Access Compliance Report

Public Rights-of-Way

(Curb Ramps)

Intersection ID: 12950	Main Street: MORRIS_FIELD_DR	Cross Street: SEYMOUR_DR	Location: W
ADA ID: 6C9B919ED39A	Ramp Type: PerpDiag	Initial Pass/Fail: Fail	Overall Compliance: No
		Severity Score: 10

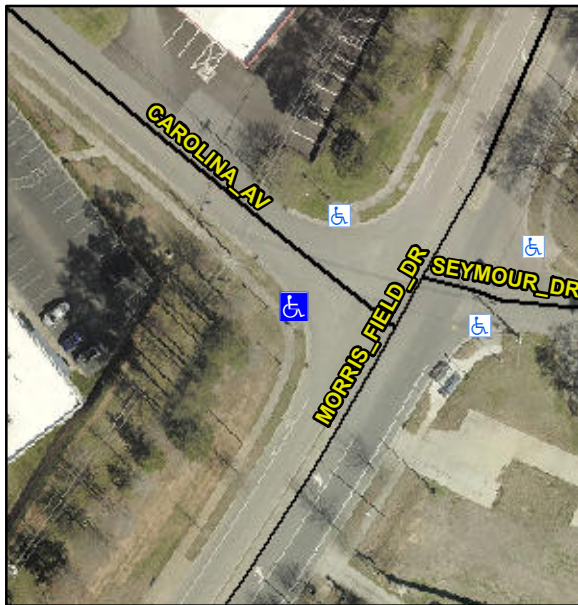
R304.5.1, R304.5.3

Compliance	Description	Data	Compliance	Description	Data
N/A	Ramp Length (in)	71.5	Yes	Ramp Slope (%)	6.8
No	Ramp Width (in)	46.0	No	Ramp XSlope (%)	3.0
N/A	Flare Type LT	N/A	N/A	Flare Type RT	N/A
N/A	Flare Slope LT (%)	N/A	N/A	Flare Slope RT (%)	N/A
N/A	Flare Traversable LT?	N/A	N/A	Flare Traversable RT?	N/A
N/A	Landing Length (in)	N/A	N/A	DWS Provided?	N/A
N/A	Landing Width (in)	N/A	N/A	DWS Contrast?	N/A
N/A	Landing Slope (%)	N/A	N/A	DWS Length (in)	N/A
N/A	Landing X Slope (%)	N/A	N/A	DWS Full Width?	N/A
N/A	Landing Curb? (Y/N)	N/A	N/A	DWS Offset (in)	N/A
N/A	Shared Landing?	N/A			
N/A	Gutter Ponding?	N/A	N/A	Gutter Slope (%)	N/A
N/A	Gutter Lip Ht (in)	N/A	N/A	Gutter X Slope (%)	N/A
N/A	Painted X Walk1?	No	N/A	Painted X Walk2?	No
	X Walk 1 Direction	To SE		X Walk 2 Direction	To NE
N/A	X Walk 1 Width (in)	N/A	N/A	X Walk 2 Width (in)	N/A
	X Walk 1 Slope (%)	1.4		X Walk 2 Slope (%)	3.1
	X Walk 1 X Slope (%)	0.4		X Walk 2 X Slope (%)	0.2

Remove & Replace Curb Ramp With Two New Directional Ramps or Equivalent.
